HCC Hearing 16 October 2026 - Dieter Engel PDP-475.4 Supplementary Note_FINAL

HUTT CITY PROPOSED DISTRICT PLAN HEARING STREAM 7 – SUBDIVISION

SUPPLEMENTARY NOTE OF DIETER ENGEL – PDP/475.4 - Hydraulic neutrality – amendments sought to SUB-S6 and SUB-R4

Submitter: Dieter Engel – PDP/475 , 10A Bloomfield Terrace, Lower Hutt

At present safety is not provided in the vicinity of the Opahu stream during heavy rainfall every few years.
1.10.3A Housing Bottom Lines

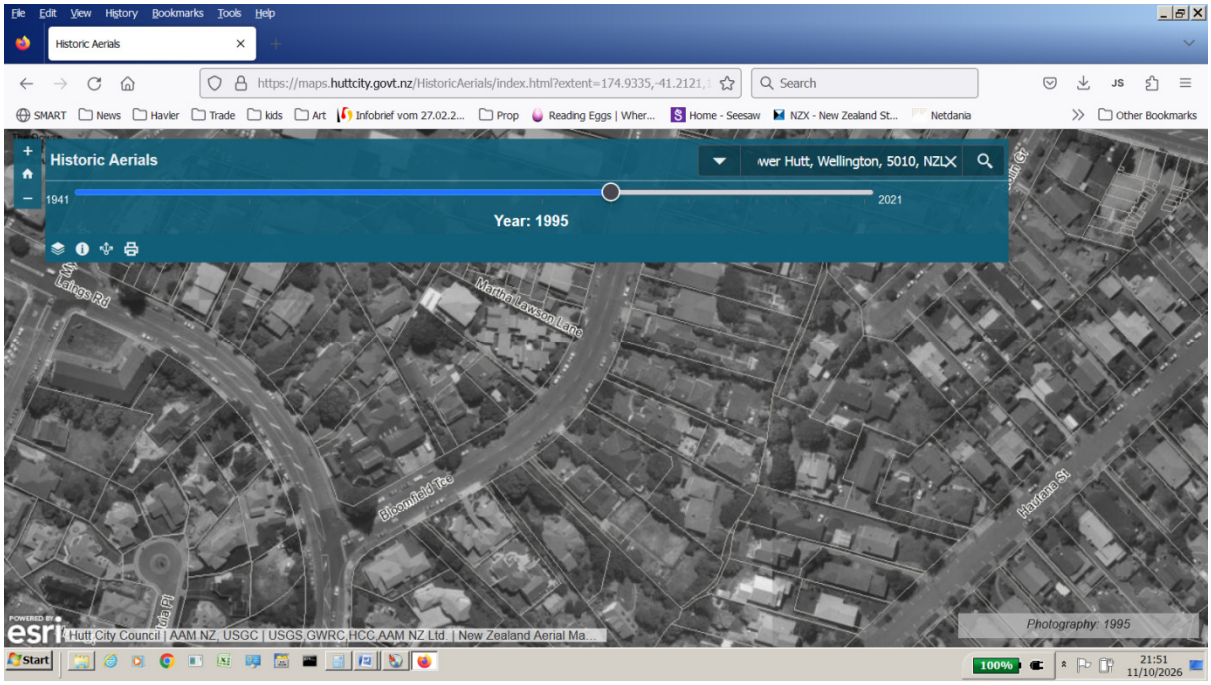
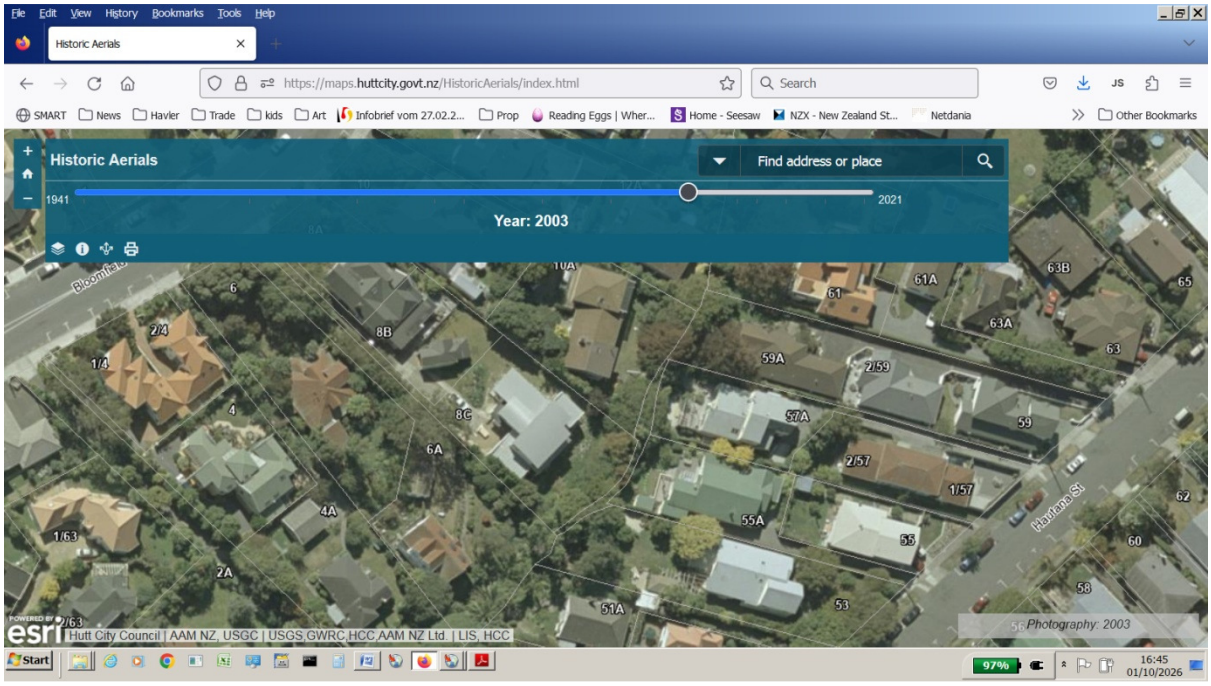
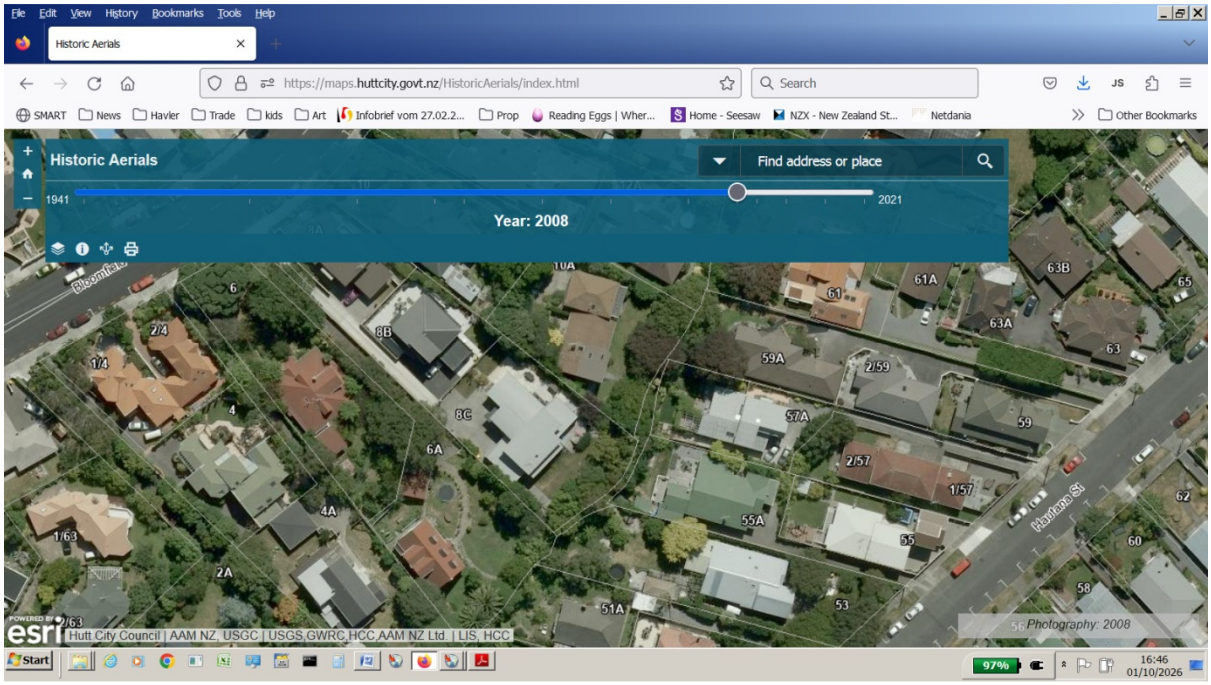
The projections above will require extraordinary investment into infrastructure and especially storm water management, control and discharge to final depositories such as Hutt river or the sea.
Both of which are not able to take surplus due to tidal movements and flow levels every time.

Could the panel please instigate that the projected increase of housing is checked for impacts and quantified in terms of amount of water, damages, cost for network and pumps as well as constant future monitoring using the Whaiwhetu stream model as a starting point.
